# BEFORE THE PLANNING ADMINISTRATOR OF THE CITY OF SALEM

## DECISION

IN THE MATTER OF APPROVAL OF	)	FINDINGS & ORDER
CLASS 3 SITE PLAN REVIEW	)	
AND CLASS 2 DRIVEWAY	)	
APPROACH PERMIT	)	
CASE NO. SPR-DAP24-24	)	
1845 BEACH AVE NE	)	AUGUST 15, 2024

**Summary:** Proposed development of a new building for Building and Ground Services and Construction Contracting use.

DATE:	02-26-2024
SCALE:	AS NOTED
DRAWN:	SG
JOB:	MGL CONSTRUCTION SHOP
SHEET:	3
OF	10 SHEETS

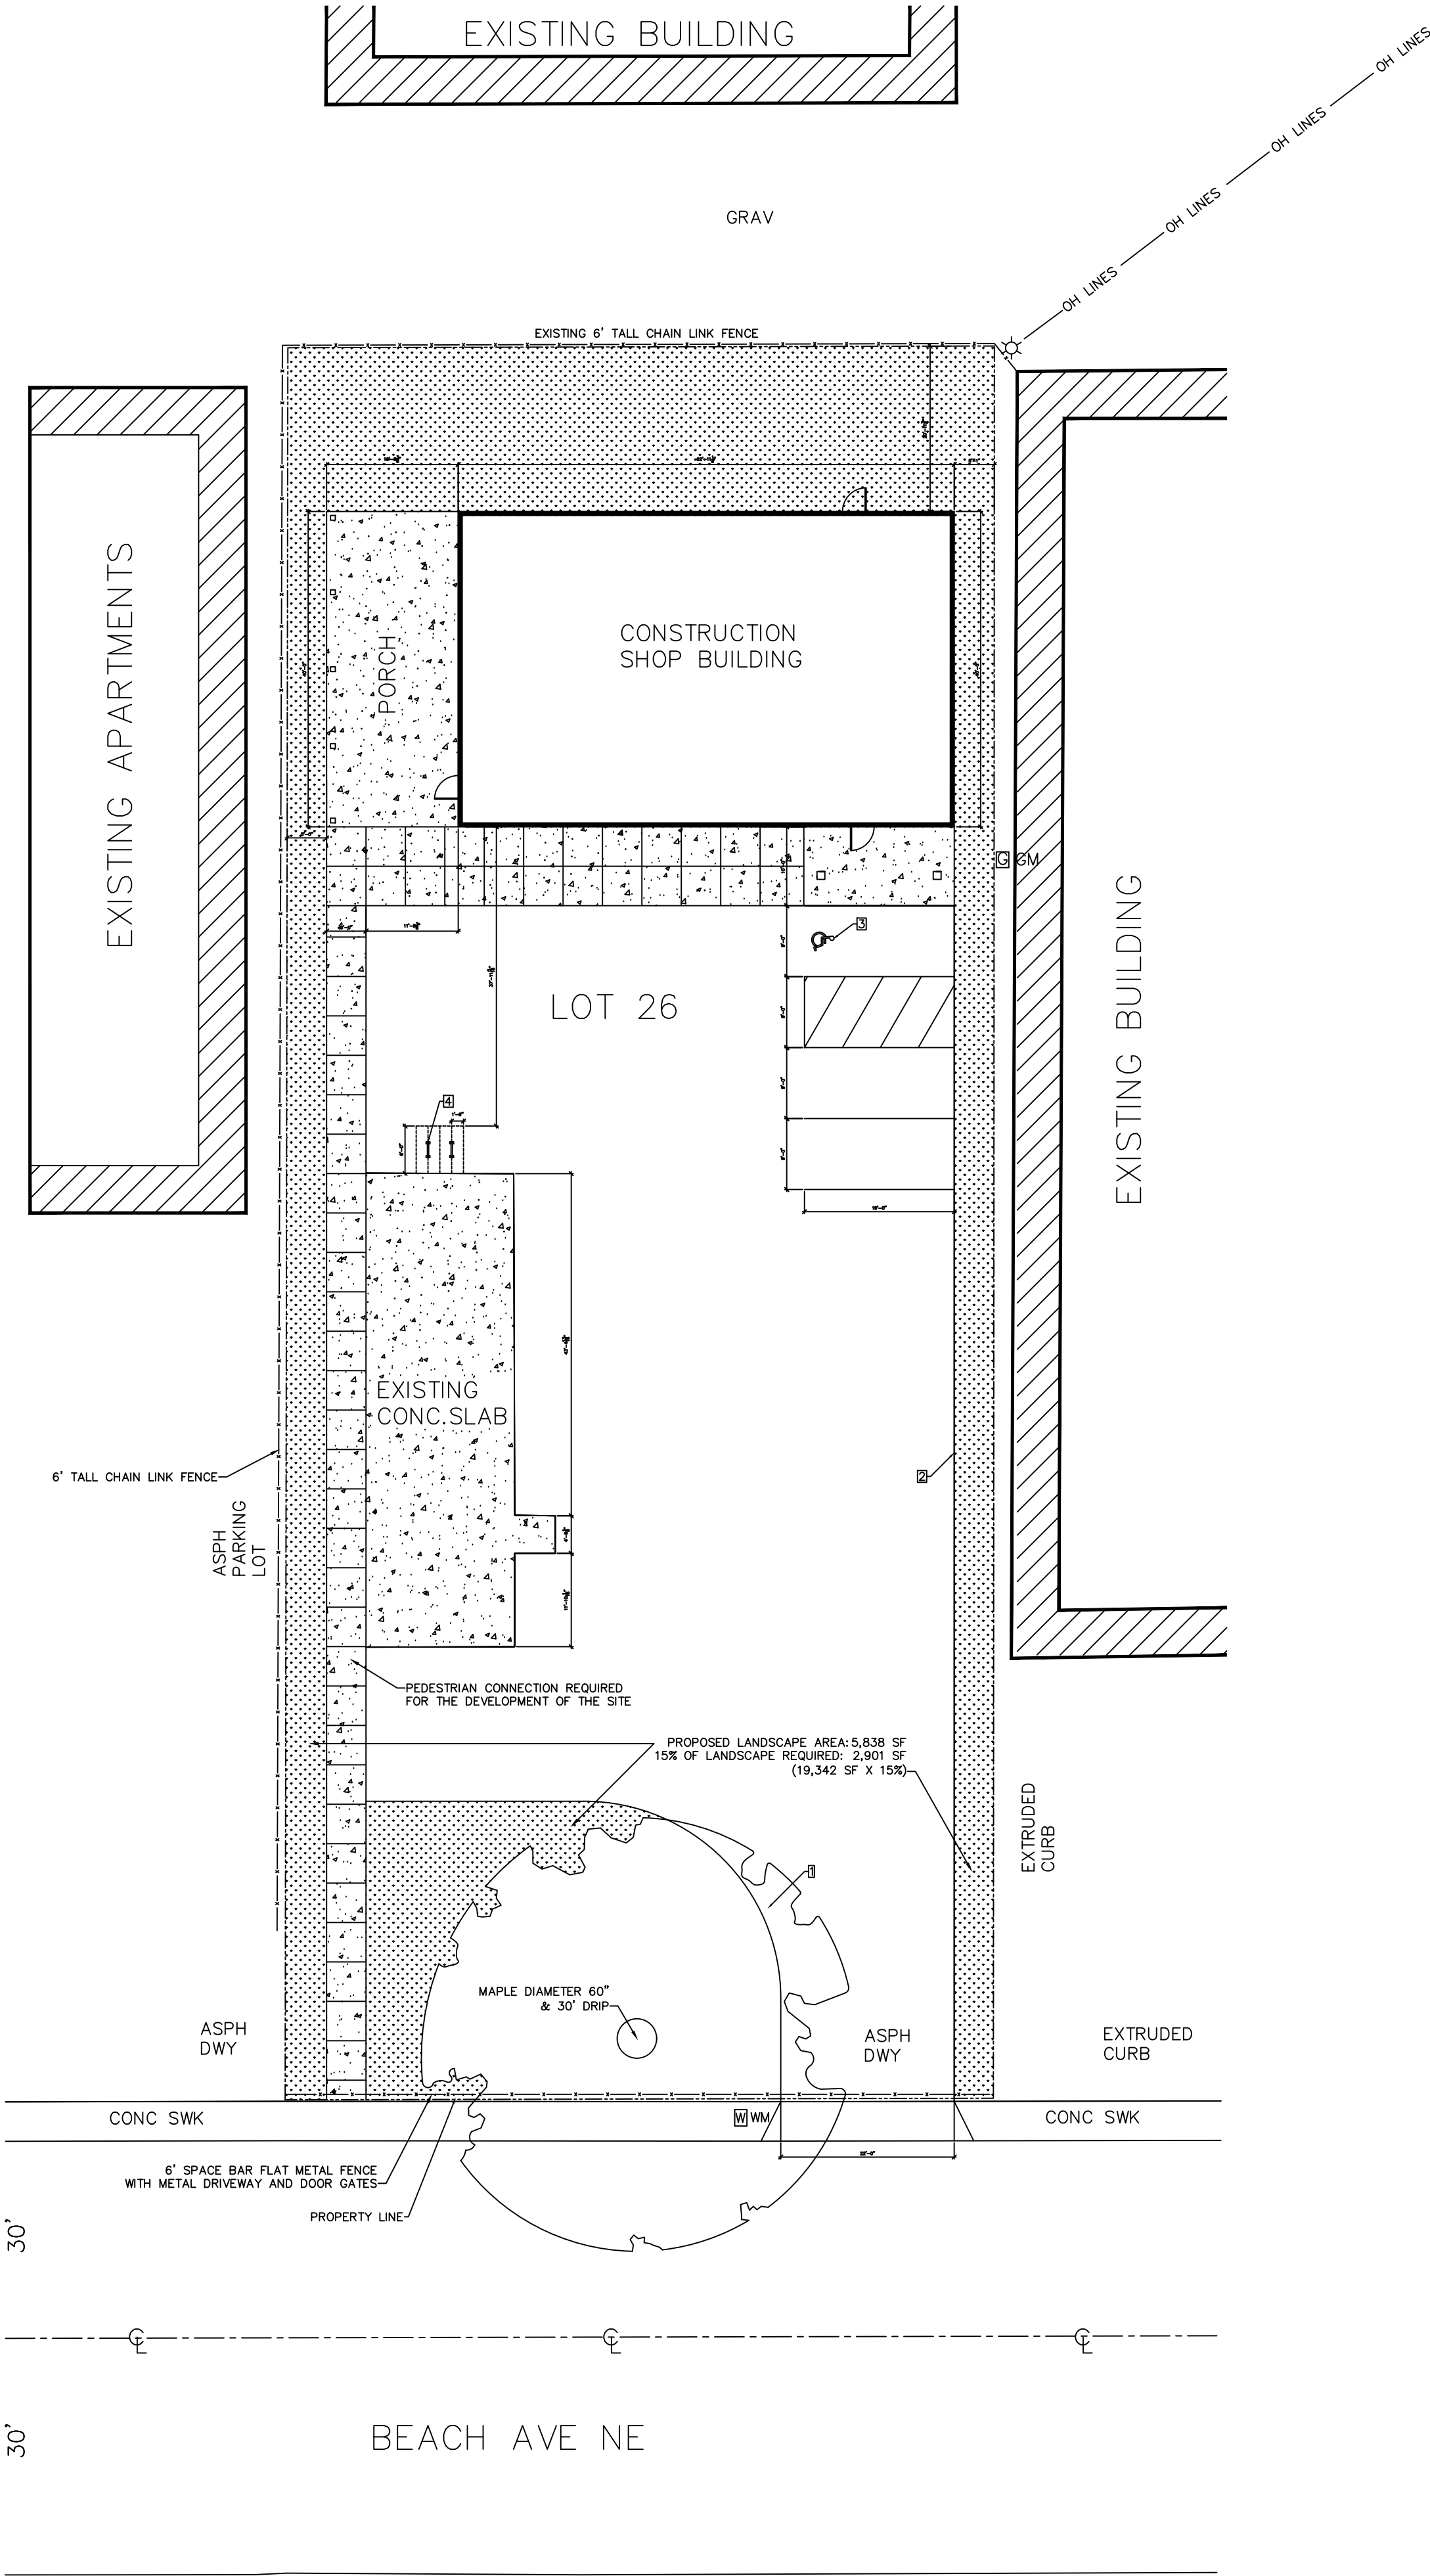
**Finding:** Per the applicant's plans, the site shall have a five-foot-wide pedestrian pathway from the northern building to Beach Avenue NE. The applicant's plans elevations do not clearly show that the primary entrance of the building shall connect into the proposed pedestrian connection, so the following is conditioned.

**Finding:** The proposed pedestrian connection does not intersect with the vehicle use areas but is located along the southern edge of the driveway. The proposed plans do not clearly show conformance with design requirement when a walkway is located to an auto travel lane. Therefore, the following condition applies:

**Finding:** As shown on the site plan, it is unclear whether the bicycle parking area has direct access to a primary building entrance and the public right-of-way, free of obstruction or barriers, in conformance with the requirements of SRC 806.060(b). Therefore, the following is conditioned:

In addition, the bicycle parking area is located within a vehicle use area where parked bicycles can be impacted by vehicles maneuvering. As such, the following is conditioned to provide protection for bicycle parked within the proposed location.

**Finding:** The subject property has two existing substandard driveway approaches onto Beach Avenue NE. The westerly driveway approach serving the subject property is not proposed to be used and does not meet the standards for a commercial driveway approach according to SRC Chapter 804. Pursuant to SRC 804.030(b)(1) driveway approaches are only permitted to provide access to an approved vehicular circulation area. As the westerly driveway approach is not proposed to be utilized for access, it shall be conditioned to be closed as a condition of approval.

**Finding:** The proposed driveway meets the standards for SRC Chapter 804; however, it is unclear from the plans submitted whether or not the proposed driveway approach will be constructed in accordance with the and Public Works Design Standards (PWDS) Standard Plan Details for Driveway Approaches. The existing driveway will be widened and it not constructed to current public works design standards. As a condition of approval, the applicant shall reconstruct the easterly driveway approach to meet current Public Works Standard Plan Details.

**Condition 1:** At the time of building permit review, the applicant shall demonstrate that all required pedestrian connections conform with the design and material requirements of SRC Chapter 800, specifically SRC 800.065(b)(1) and 800.065(c).

**Condition 2:** At the time of building permit, the applicant shall demonstrate that the bicycle parking is in conformance with SRC 806.060(b).

**Condition 6:** Permanently close the unused westerly driveway approach and replace with curbs and sidewalk in accordance with the Public Works Design Standards.

**Condition 8:** Construct the easterly driveway approach to meet current Public Works Design Standards, Standard Plan Details for driveway approaches.
